SUBJECT: Forwards responses to NRC request for info re DNBR core protection calculator & proprietary & nonproprietary CEN-184(S) "Responses to Questions on Documents Supporting Songs-2 Licensing Submittal."
See subject files

Subject: Docket Nos. 50-361 and 50-362
San Onofre Nuclear Generating Station
Units 2 and 3

CPC

FIGURE 1

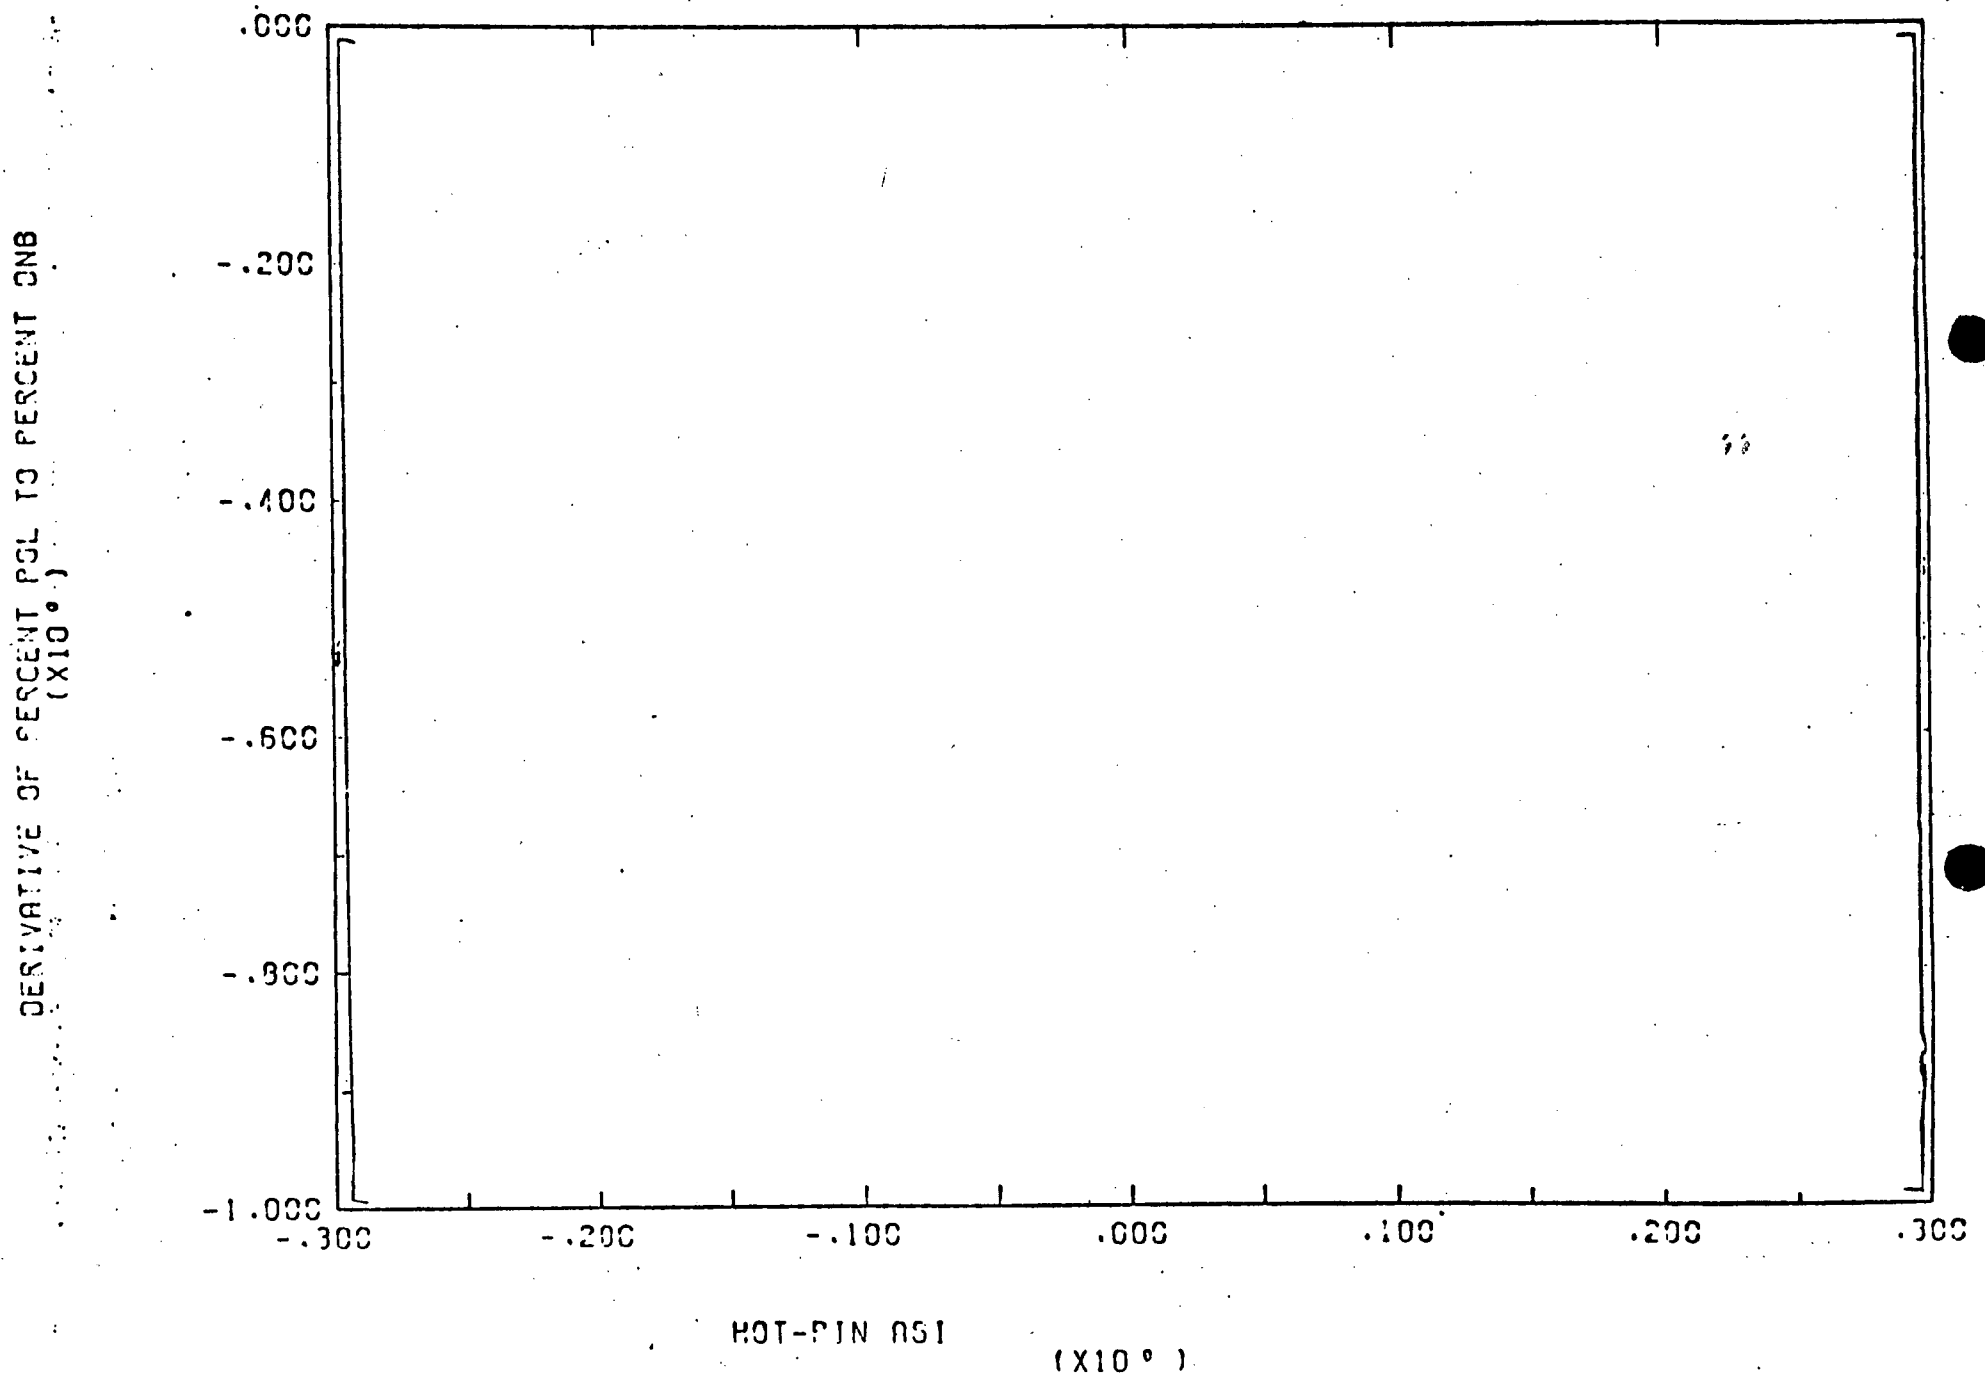
Provide a sensitivity study of DNBR vs. BERR1 for various ASI and flow conditions.

A sensitivity study of the derivative, $\frac{d \% \text{ OPM}}{d \% \text{ DNBR}}$ was performed using the CETOP-D SONGS-2 Cycle 1 model. This study examined the change in overpower margin relative to change in the DNBR limit from [] to [] for the following conditions:

A plot of $\frac{d \% \text{ OPM}}{d \% \text{ DNBR}}$ for each condition is given in Figure 1.
